**ISSUE:** Certificate of Appropriateness for alterations

**LOCATION:** Old and Historic Alexandria District  
418 and 418 A South Washington Street

**BAR #2022-00077**  
**418 and 418 A South Washington Street**

### **Update**

**Figure 2: Comparison of previous design (left) and revised design (right) for the building entry**

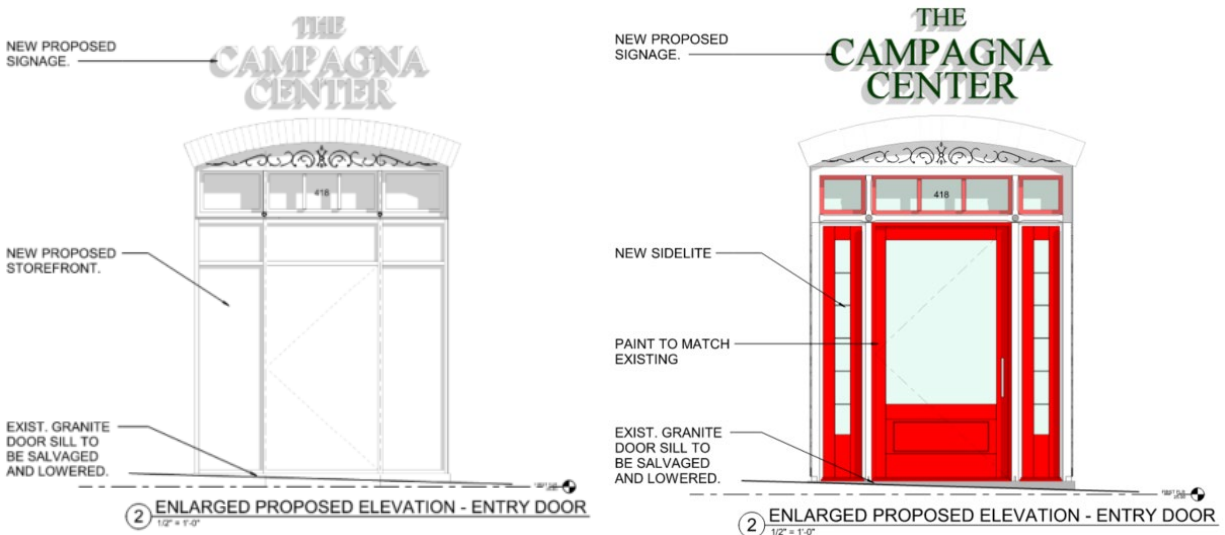
As requested by the BAR, the applicant is proposing a modified design for the main building entry on the west elevation. During the previous BAR hearing, the Board expressed concern that the proposed storefront door and sidelight assembly were too contemporary and were not compatible with the historic transom to remain or the overall design of the building. In the revised design, the applicant is proposing to return the overall configuration to its original condition by installing wood jamb posts to match the previously relocated ones in their original location. A large, paneled, wood and glass door and sidelights will be painted to match the historic transom to remain. See Figure 2 below for the comparison of the previously submitted design (left) and the revised design (right) for the building entry.

The Design Guidelines state that “Exterior doors and storm doors constitute prominent visual details of the main façade of a building...Exterior doors and surrounding details should complement the architecture of the structure and not detract from it.” By locating the jamb posts in their original location and installing vertical sidelights, the design will reflect the original design intent. The lowering of the door threshold will allow the entry to be accessible but will require the use of an oversized door. The proposed door is taller and wider than typical doors, but staff finds the design of the door itself with the large, glazed area and paneled lower section to be proportionally comfortable. Staff supports the returning of the jamb posts to their original location and recreation of the original entry configuration and finds that the design is clearly of its time while also being compatible with the historic fabric.

Staff recommends approval of the Certificate of Appropriateness for alterations with the condition that the door and sidelights comply with BAR window glazing specifications: clear, non-reflective, and without tint.
